QUALITY ASSURANCE -- NON-CONFORMANCE REPORT

Location: Changxing Island, Shanghai, China**Report No:** NCR-000840**Prime Contractor:** American Bridge/Fluor Enterprises, a JV**Date:** 16-Sep-2010**Submitting Contractor:** Zhenhua Port Machinery Company, Ltd (ZPMC), Changxing Island**NCR #:** ZPMC-0802**Type of problem:**

Welding	Concrete	Other	
Welding	Curing	Procedural	Bridge No: 34-0006
Joint fit-up	Coating	Other	Component: Segment 13BE and 13CE
Procedural	Procedural	Description: Missed UT indications

Subject: NCR No. ZPMC-0802

LONGITUDINAL DIAPHRAGM SUB-ASSY ~ MARK LD3028A
(TYPE 2) (E3, LOOKING NORTH - DEVELOPED)

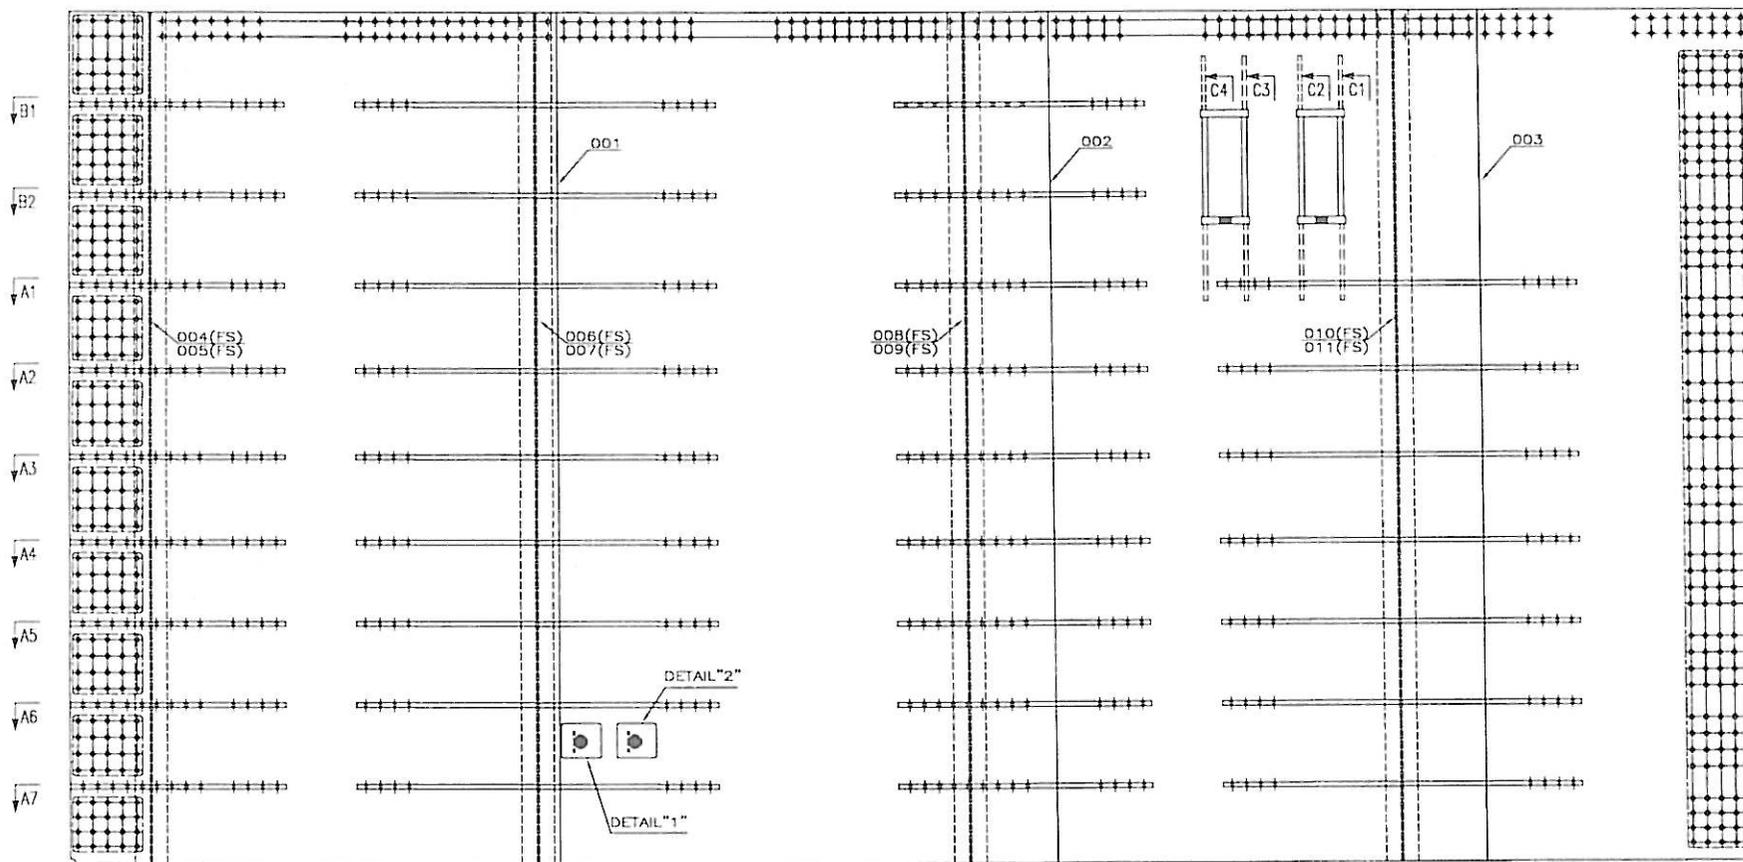
- Three (3) longitudinal linear class "A" rejectable indications measuring approximately 180mm~260mm in length.
- The welds are identified as LD3028-001-031, LD3027-001-026 and LD3030-001-053.

- The indication db rating for joint LD3030-001-053 is a +5.
- The depth of the indications are from 20mm~23mm deep.
- The Weld LD3028-001-031 is joining longitudinal diaphragm (X3682A) to lifting Lug.

These welds were designated to be PJP welds and no UT is required. The NWIT were submitted due to the internal fault between the floor QC & NDT operator of ZPMC. ZPMC is providing the MT records to show the acceptance of these welds and is requesting closure of this NCR.

WELD I.D. 焊缝编号	DISCONTINUITY不连续性			ACCEPT 接受	REJECT 拒收	REMARKS 备注
	INDICATION 指示	TYPE 类型	LENGTH IN mm 长度			
LD3028-001-031				ACC.		100%MT
LD3027-001-026				ACC.		100%MT
LD3030-001-053				ACC.		100%MT
BLANK

ZPMC SHANGHAI ZHITIKA PORT MACHINERY CO., LTD.		 SHANGHAI ZHITIKA PORT MACHINERY CO., LTD.
WELDING MAP		
DRAWN DATE	SHOP DRAWING NO. D3027	PAGINATION 1/2

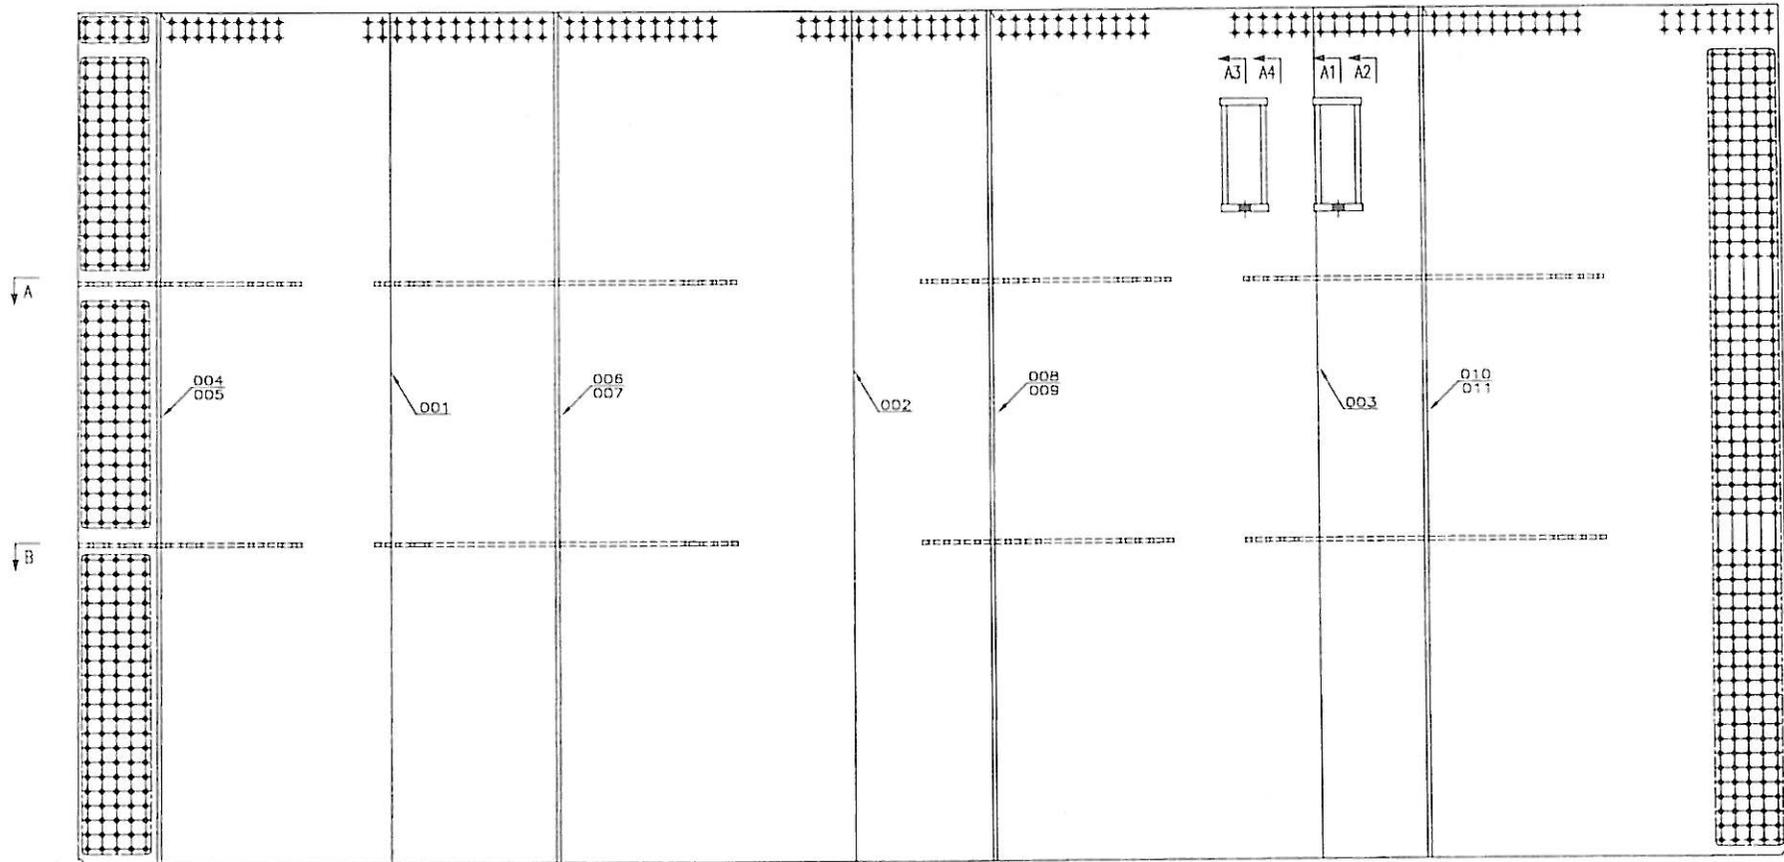
- The Weld LD3027-001-026 is joining longitudinal diaphragm (X3684B) to lifting Lug.
- The Weld LD3030-001-053 is joining longitudinal diaphragm (X3685A) to lifting Lug.

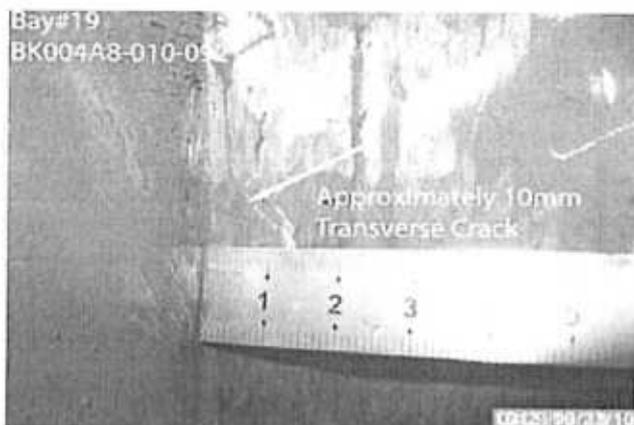
During the Quality Assurance (QA) Magnetic particle Testing (MT) review of welds located on OBG Bike path BK004A-010, this QA Inspector discovered the following issue:

- One transverse crack that measured approximately 10mm in length.
- The weld is identified as BK004A8-010-092.
- The weld is a Partial joint penetration (PJP) T joint, joining the Stringer plate (BKX9C) to the End diaphragm plate (BKX11GA).
- The Y Location is 100mm from the bearing plate.
- The OBG Bike path is located in BAY#19.
- This crack is clearly marked on the material on/near the weld.
- This weld joint is designated as Non-Seismic performance critical (Non-SPCM) weld member.
- The Notice of Witness Inspection Number (NWIT) is 006731.
- The crack is located within the area that has been re-tested and accepted by ZPMC Quality Control (QC) subsequent to the heat straightening procedure.

ZPMC acknowledged the indication was missed and has issued an internal NCR to address this problem. ZPMC has repaired the indication and is providing the NDT record to show the acceptance of this weld. Based on this, ZPMC is requesting closure of this NCR.

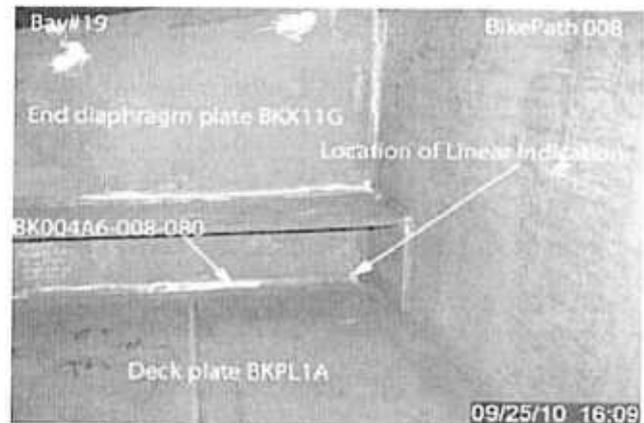
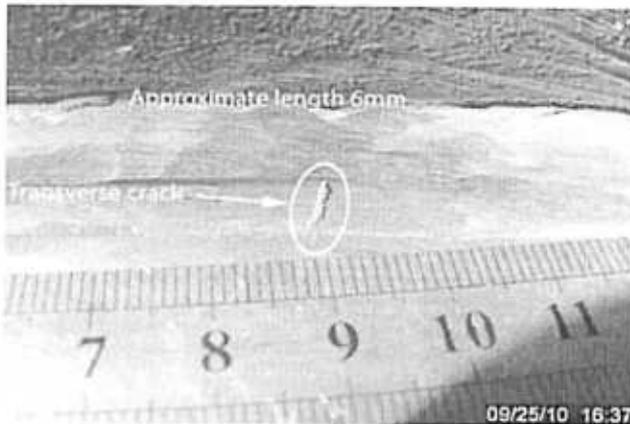
- One Longitudinal linear crack in the weld measuring approximately 15mm in length.
- The weld is identified as BK004A6-008-080.
- The weld is partial joint penetration (PJP), joining the End Diaphragm plate identified as BKX11G to the Deck Plate identified as BKPL1A.
- This weld joint is designated as Non-Seismic performance critical (Non-SPCM) weld member.
- The crack is clearly marked on the material near the weld.
- The OBG Bike Path 008 is located in Bay #19.

Quality Assurance (QA) Magnetic Particle Testing (MT) review of fillet welds located on OBG bike path BK004A-018, this QA Inspector discovered the following issues:

- One (1) transverse crack found on the weld measuring approximately 6mm in length.
- Y location of the indication is measured to be 2160mm.
- The crack is clearly marked on the weld joint.
- The weld is identified as: BK004A3-018-052.
- The Weld is a fillet weld joining the stringer plate (8C) to the deck plate of bike path.
- The member is located in bay 11.

ZPMC acknowledged the indications were missed and has issued an internal NCR to address this problem. ZPMC has repaired the indications and is providing the NDT records to show the acceptance of the welds. Based on this, ZPMC is requesting closure of this NCR.

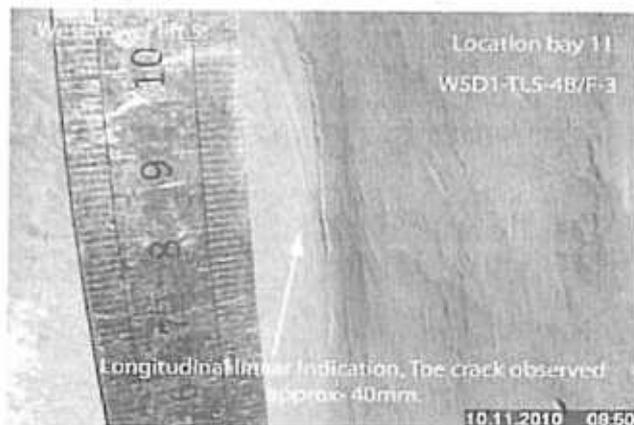
During the Quality Assurance (QA) Magnetic Particle Testing (MT) review of welds located in West Tower lift 5 Grillage plate, WSD1-TL5-4B/F-3, this Quality Assurance (QA) Inspector discovered the following issues:

-One longitudinal toe crack measuring approximately 40mm in length.

-The weld is identified as: WSD1-TL5-4B/F-3.

-The Weld is a Complete Joint Penetration (CJP) weld, joining the grillage plate to skin plate.

ZPMC acknowledged the indication was missed and has issued an internal NCR to address this problem. ZPMC has repaired the indication and is providing the NDT record to show the acceptance of this weld. Based on this, ZPMC is requesting closure of this NCR.

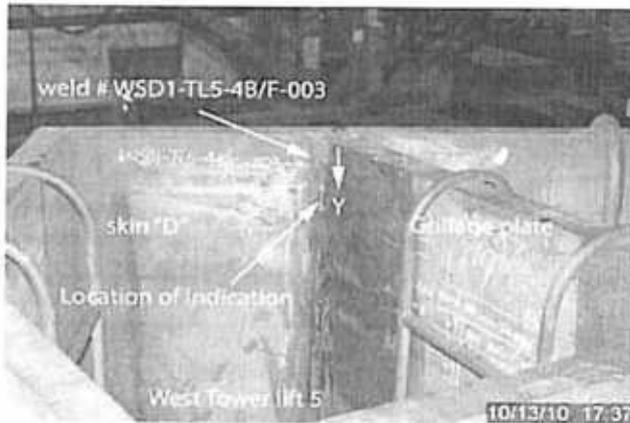
During the Quality Assurance Ultrasonic Testing (UT) verification of welds located on grillage plate of West Tower lift 5, this Quality Assurance (QA) Inspector discovered the following issues:

- One class "A" longitudinal indication measuring approximately 50mm in length.
- The depth of the indication is 57mm.
- The db rating is -2.
- The material thickness is 65mm.
- The weld is identified as: WSD1-TL5-4B/F-003.
- The Weld is a Complete Joint Penetration (CJP) with steel backing, T-joint, joining the grillage plate to the skin plate (skin "D").
- The "Y" location of the indication is 110mm from top side
- The indication is clearly marked on the component.
- The member is located in Bay 11.

-Attached photographs provide additional location details.
